File ID: 2021-2426

Application of Amanda Woodruff to rezone property from R-85 (Residential Medium Lot-85) District to RSM (Small Lot Residential Mix) District to construct three single-family attached townhomes, at 3720 Jamieson Place.

Petition No.: Z-21-1244669 (2021-2426)

STAFF ANALYSIS

ZONING EXHIBIT
 2/26/2021
 SCALE: 1" = 20'
 JOB: 2021-JCH-02
 ISSUE: B.1
 SHEET --- OF 1

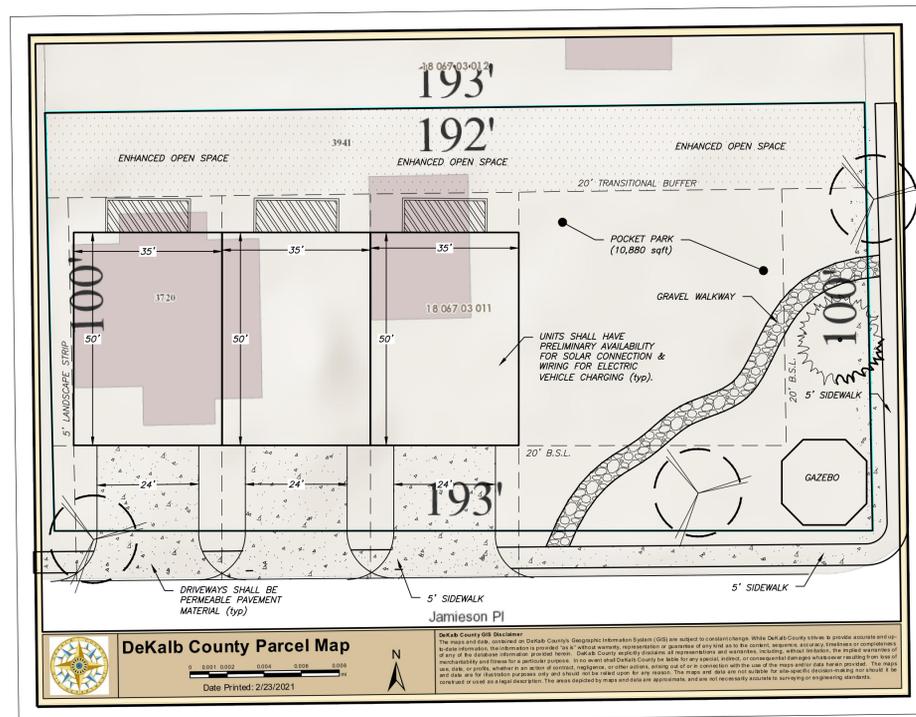
Since the June 22nd Board of Commissioners meeting, the applicant has submitted a revised concept plan and tabular data which appears to show compliance with the RSM zoning district requirements and addresses Planning Department Staff's previous concerns about clarifying which type of density bonuses are being provided, showing compliance with open space requirements, and providing a 20-foot wide transitional buffer along the north property line abutting a single-family residential subdivision to enhance compatibility with the surrounding area. The revised plan shows three single-family attached townhomes at a density of 6.8 units per acre (three residential units divided by .44 acres) with three-story building heights. Based on the submitted conceptual elevations, stucco buildings with a significant number of windows are proposed which appear to comply with the building material requirements of the *Zoning Ordinance*. Based on the submitted concept plan and tabular data from the applicant, it appears that the project complies with the RSM district standards. The RSM district allows a base density of four units per acre, with densities up to 8 units per acre if density bonus qualifications are met. To achieve a density of 6.8 units per acre, the applicant is requesting a 100% density bonus based on the inclusion of enhanced open space (i.e. $4 \text{ DU/AC} \times 100\% = 4 \text{ DU/AC}$; $4+4=8 \text{ DU/AC}$ (maximum)). To get this type of density bonus, at least 35% of the open space must be enhanced open space such as dog parks, pocket parks, pool amenities, etc.. The site plan indicates that the applicant is providing much more enhanced open space than required (i.e. 35% required (.15 acres); 56% provided (.25 acres)), and that all of the open space is enhanced open space consisting of a 10,880 square foot pocket park. While not required, the site plan shows a 20-foot wide undisturbed buffer along the north property line which abuts single-family residential homes to provide additional compatibility for surrounding properties. Sidewalks and street trees along Jamieson Place and Market Street are also shown on the concept plan, and the tabular data shows compliance with the front, side, and rear building setbacks of the *Zoning Ordinance*.

MIN OPEN SPACE	None required since site is less than 5 acres and less than 36 residential units.	56% enhanced open space.	Yes
TRANSITIONAL BUFFER	None required since abuts properties in City of Clarkston.	None required, but 20 foot wide transitional buffer provided.	Yes
PARKING	<p>Min of 5 spaces (1.5 spaces per dwelling unit plus .25 spaces per unit for guest parking)</p> <p>Max of 9 spaces Three (3) spaces per dwelling unit, plus one-quarter (0.25) space per dwelling unit to accommodate guest parking</p>	6 spaces (includes one space in garage and one on driveway).	<p>Yes.</p> <p>Yes</p>
SIDEWALKS AND STREETSCAPING	5-ft. sidewalk and 6-ft. landscape strip, with street trees 30 ft. on center along Jamieson Place and Market Street frontage.	Street trees and sidewalk shown along frontage	Yes based on conceptual plan submitted
STREET LIGHTS AND PEDESTRIAN LIGHTS	Street lights shall be installed along public right of way within the landscape strip spaced at a maximum distance of 100 ft on center. Pedestrian lights shall be installed along public right of way at a maximum distance of 40 ft on center.	Information not provided	No. Non-compliance will necessitate a variances.

* Please note that the sewer capacity has not been reviewed or approved for this project. A Sewer Capacity Request (SCR) must be completed and submitted for review. This can be a lengthy process and should be addressed early in the process.

Consult the Georgia DOT as well as the DeKalb County Transportation Department prior to land development permit. Verify widths from the centerline of the roadways to the property line for possible right-of-way dedication. Improvements within the right-of-way may be required as a condition for land development application review approval. Safe vehicular circulation is required. Paved off-street parking is required.

N3. Jamieson Place and Market Street both local residential. Please see Chapter 5 of the Zoning Code and Section 14-190 of the Land Development Code for required infrastructure improvements. Dedicate 27.5 feet of right of way from centerline OR the amount to include all public infrastructure, whichever greater. Requires 6-foot sidewalks, streetlights, 6-foot landscape strip. Reviewer will be looking at driveway placement in relationship with the intersection during the development review process- please maximize during design.

Field and plans reviewed. Found nothing that would disrupt traffic flow.

1. Up to a maximum of three (3), fee-simple, single-family attached townhomes.
2. The townhome building shall be designed with a residential front façade that is harmonious with the surrounding residential vernacular architecture. Proposed elevations must be submitted to the Director of Planning & Sustainability, or his designee, prior to land development phase approval.

3. A minimum of 35% enhanced open space shall be provided, and shall comply with the minimum size and design requirements for pocket parks. Existing healthy trees within the enhanced open space areas shall be preserved subject to approval of the County Arborist. The developer shall create a Homeowner's Association which shall be responsible for maintaining the open space and landscaping.

4. A 20-foot wide transitional buffer shall be provided along the north property line. Healthy existing trees within the transitional buffer shall be preserved and supplemented with new trees to form an effective visual screen as approved by the County Arborist prior to the issuance of any certificates of occupancy.
